FINAL ENVIRONMENTAL IMPACT REPORT JANUS SOLAR AND BATTERY STORAGE PROJECT

COUNTY OF COLUSA COMMUNITY DEVELOPMENT DEPARTMENT

State Clearinghouse No. 2024061043 November 26, 2024

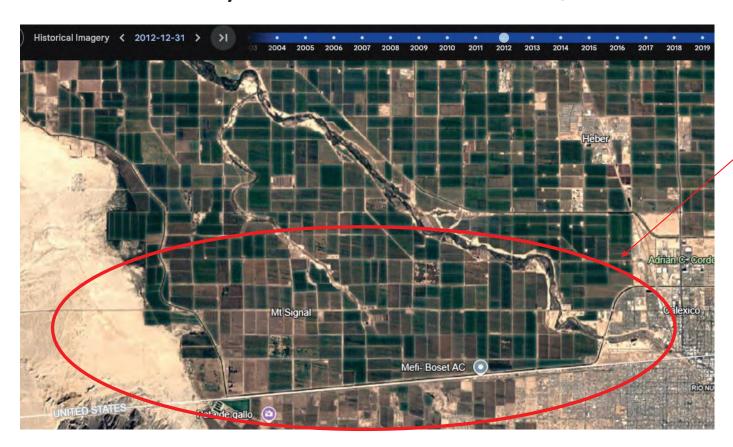
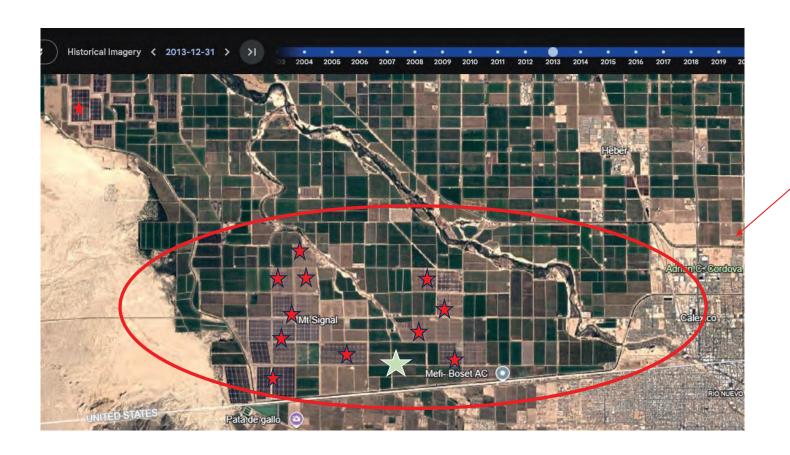
DEIR needs to analyze relative to **zone of influence** and loss of farmlands as required by CEQA. By not including solar developments into the LESA analysis, it leads to incorrect analysis relative to farmland loss as well as foreseeable environmental impacts.

Imperial County California: 2012, ZOI factor

Focus on changing landscape

Imperial County California: 2013

Focus on changing landscape & island of farmland;

Impact of Solar to Mount Orab, OH, from 2017 to 2022; **LESA** model in DEIR does not account for solar & **ZOI**.

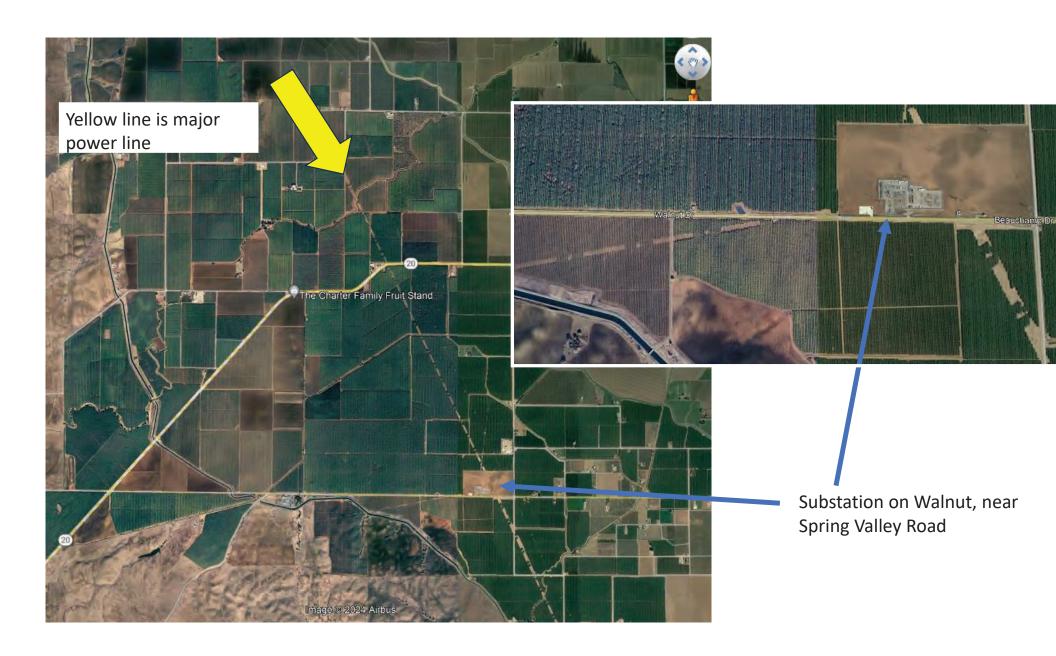
Last update (correction) to LESA model Appendices A and B (**dated 2011**) per Conservation.ca.gov;. Does the DEIR modeling account for changes to solar development; what and how do factor weight impact analysis, ZOI, and are they current and being applied correctly?

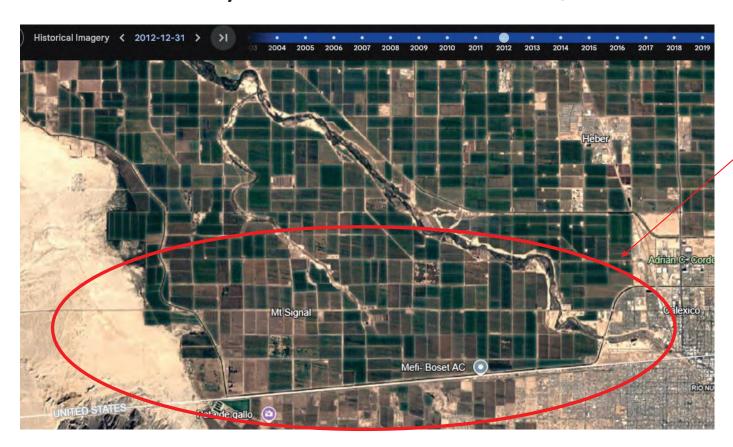
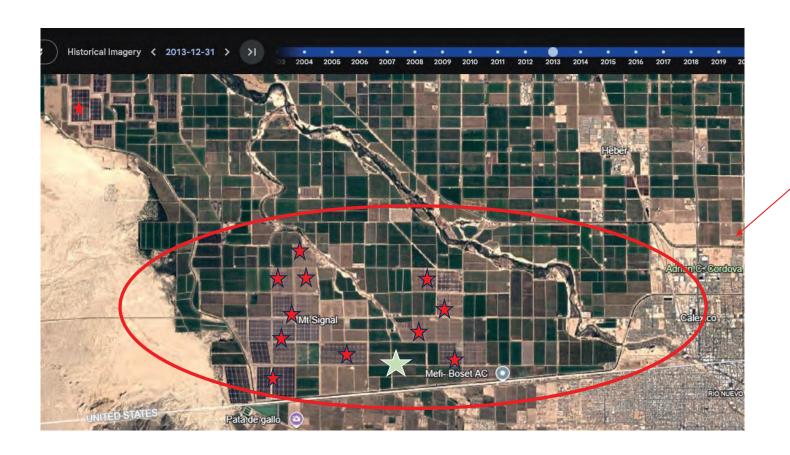
DEIR needs to analyze relative to **zone of influence** and loss of farmlands as required by CEQA. By not including solar developments into the LESA analysis, it leads to incorrect analysis relative to farmland loss as well as foreseeable environmental impacts.

Imperial County California: 2012, ZOI factor

Focus on changing landscape

Imperial County California: 2013

Focus on changing landscape & island of farmland;

Impact of Solar to Mount Orab, OH, from 2017 to 2022; **LESA** model in DEIR does not account for solar & **ZOI**.

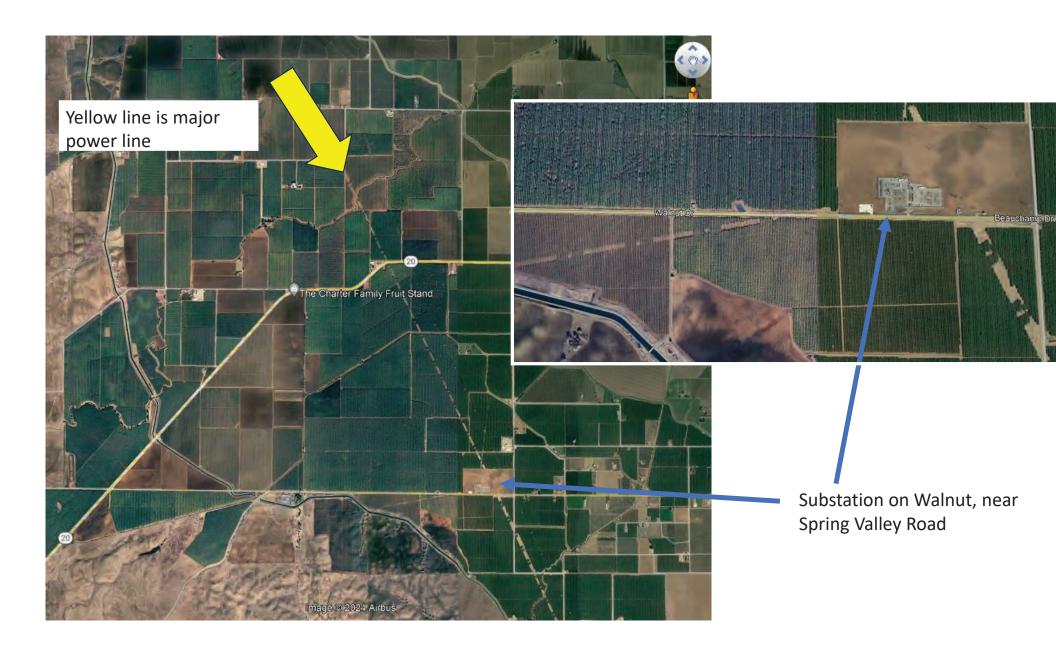
Last update (correction) to LESA model Appendices A and B (**dated 2011**) per Conservation.ca.gov;. Does the DEIR modeling account for changes to solar development; what and how do factor weight impact analysis, ZOI, and are they current and being applied correctly?
